Bayside Council submission on State Significant Development Application for 792-794 Botany Road and 33-37 Henry Kendall Crescent, Mascot (SSD – 72393459)

Attachment 1: State Significant Development Application 792-794 Botany Road and 33-37 Henry Kendall Crescent, Mascot SSD- SSD – 72393459 – Bayside Council Submission

Figure 1: Current proposal

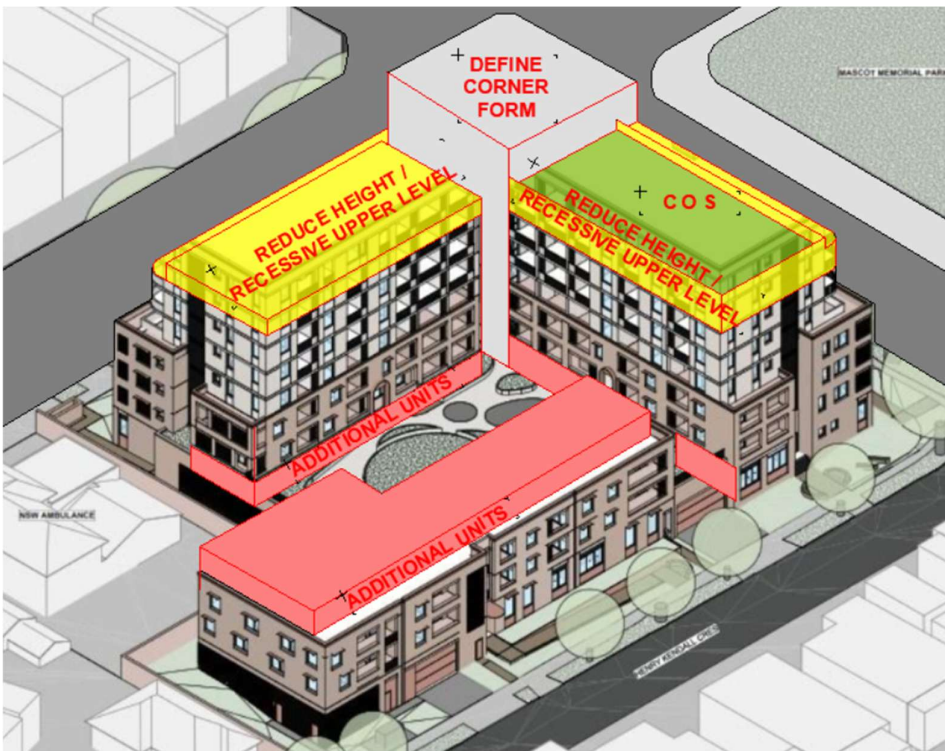
The proposed increased FSR combined with the introduction of an above ground carpark has significantly increased the perceived mass of the proposal.

The current proposal presents a continuous 8 storey building to Botany Road. The approved PP addressed the corner of Botany Road and Coward Street with an 8 storey building that stepped down to a 6 storey building fronting Botany Road. The stepped building form assisted in providing a clear street corner form and provided a transition in scale more consistent with the evolving scale of Botany Road.

The PP also provided a building form fronting Coward Street that stepped down to the west on the corner of Coward and Henry Street. The stepped built form provided a transition in scale with the lower scale residential neighborhood to the west and limited the extent of over shadowing of the park.

The altered massing of building responds poorly to the immediate context of the site, therefore further development is recommended.

To provide an acceptable contextual response it is recommended that the proposal is developed with a basement carpark and an FSR compliant with the approved PP. Further refinements of the building form should be undertaken to provide an acceptable response to the immediate context of the site. This should include:

- The reduction of building mass fronting Coward Street to reduce overshadowing of the park and create the opportunity for a roof terrace to provide more amenable COS overlooking the park.
- The reduction of building mass fronting Botany Road to assist in providing a clearly defined street corner building form and providing an appropriate transition in scale with evolving street scale of Botany Road.

To assist in accommodating the developments outlined above consideration should be given to:

- The reinstatement of a basement carpark and the relocation of service areas to the basement, to allow more residential units to be incorporated at ground floor level.
- The addition of an additional story to the three-storey building fronting Henry Kendall Crescent.
